MEMORANDUM

Re: **HMH Carrier Clinic, Inc.**
Preliminary and Final Major Site Plan and Bulk Variances
Revised Application Submission

252 County Route 601
Block 2001, Lot 2
Block 1001, Lot 14.02
MR Mountain Residential Zone

Date: December 14, 2023

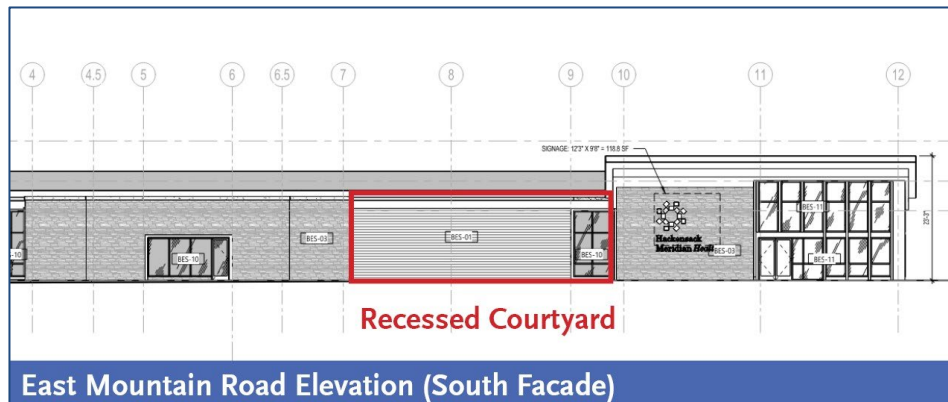
- 10.4 **Front Courtyard Walls:** *More information is required.* The plan proposes a 50-foot by 29-foot recessed front wall with a courtyard-like lawn area facing East Mountain Road. Due to the curvature of East Mountain Road and the difference in grade between the roadway and building foundation, the facade may be

particularly visible from approaching roadway traffic. Elevations of the east- and west-facing front courtyard walls are not shown. This office recommends that the façade carry the use of the stone veneer around the outside corner walls of the courtyard (those not shown) to suggest a structurally realistic appearance.
